STUDER

Service Information

Hardware Modification Kit
40/88 for A820 MCH

SI 120b/88 E

MP UNIT AUDIO CONTROL PCB 1.820.782.20 ASY 1, GRP 21 ELM 21

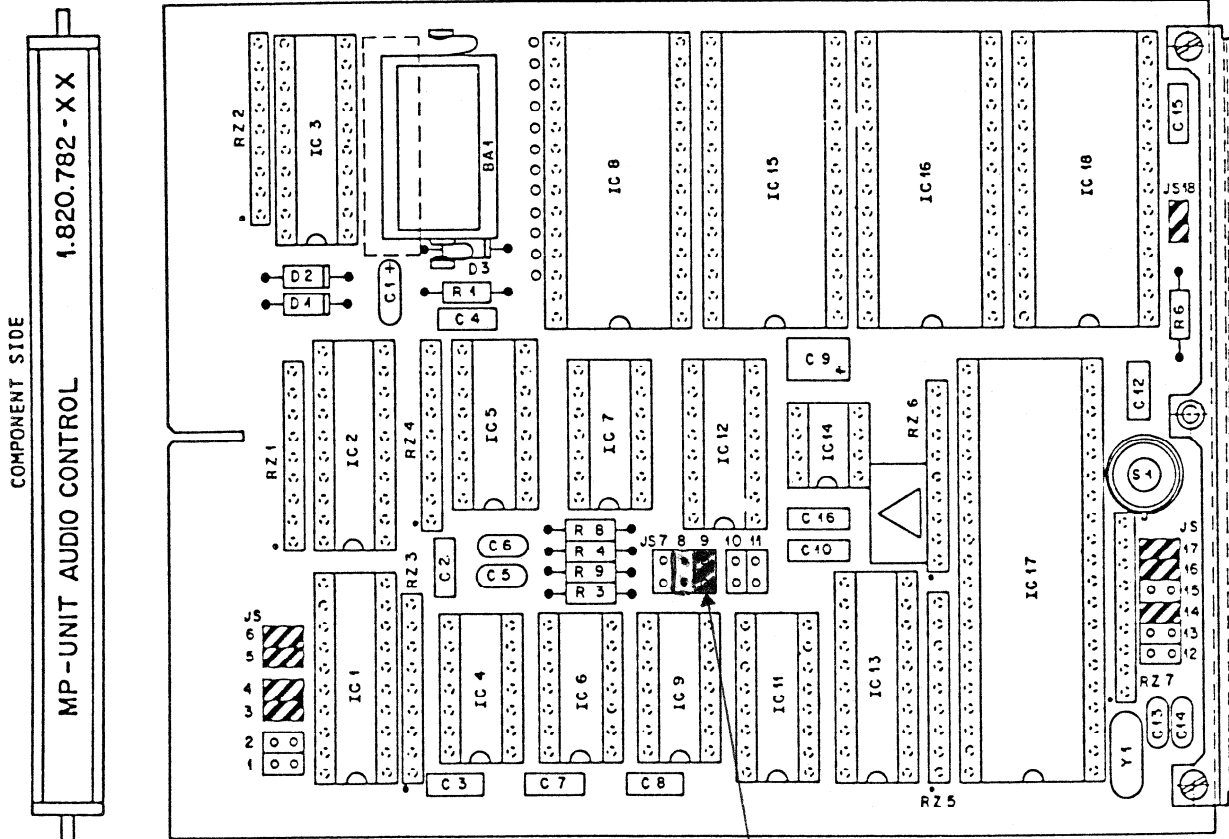
Insert Jumper in position 9 instead of position 8.
(see attached Lay-out)

Jumper must be inserted in position 9 !
